**SUSQUEHANNA STEAM ELECTRIC STATION
PROPOSED CHANGE TO WATER TREATMENT
INFORMATION CONTAINED IN THE RENEWAL
APPLICATION FOR THE SSES NPDES PERMIT
PLA-5310**

SUSQUEHANNA STEAM ELECTRIC STATION
WATER TREATMENT CHEMICAL UPDATE
NPDES PERMIT NO. PA 0047325
CCN 741326 FILE R9-8A
PLE-0022311

PPL Susquehanna, LLC is updating water treatment information previously submitted to the Pennsylvania Department of Environmental Protection (PaDEP) for the Susquehanna Steam Electric Station. This information is provided in response to requirements of "Permitting Guidance on Conditioned Water Discharges and Use of Chemical Additives, Revised July 24, 1992".

7. Line Drawing. See instructions

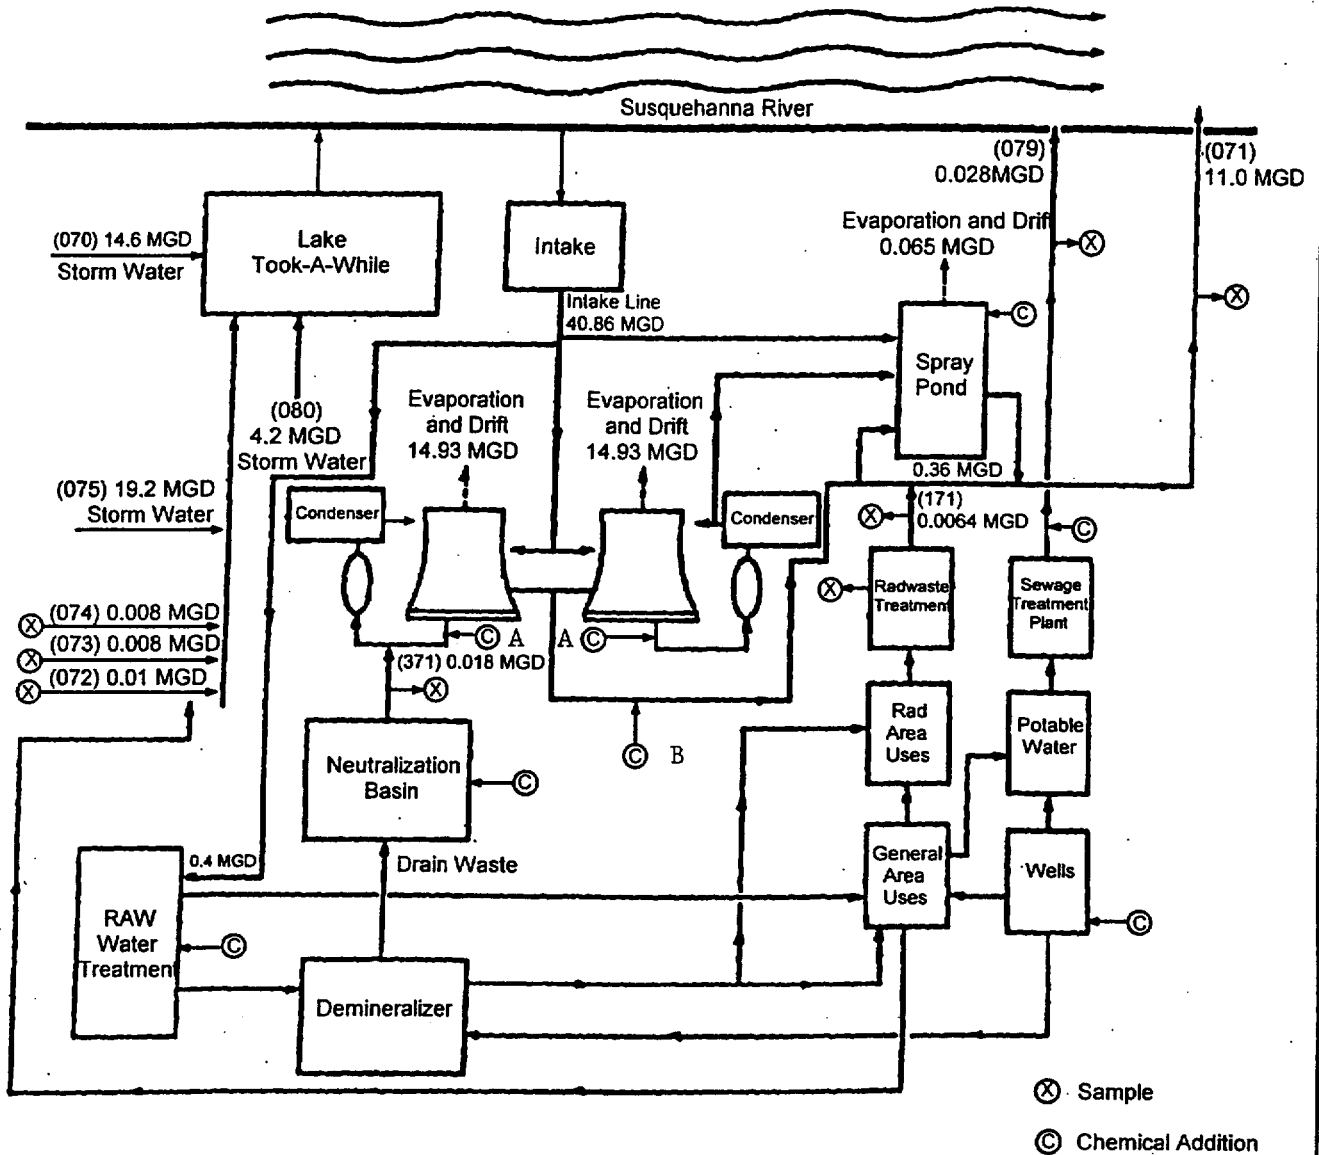
See Figure 1, Flow Diagram for location of chemical addition and discharge through Outfall 071, Cooling Tower Blowdown

See Figure 1, Flow Diagram for location of chemical addition and discharge through Outfall 071, Cooling Tower Blowdown

A Spectrus CT1300 Injection
 B Spectrus DT1400 Injection
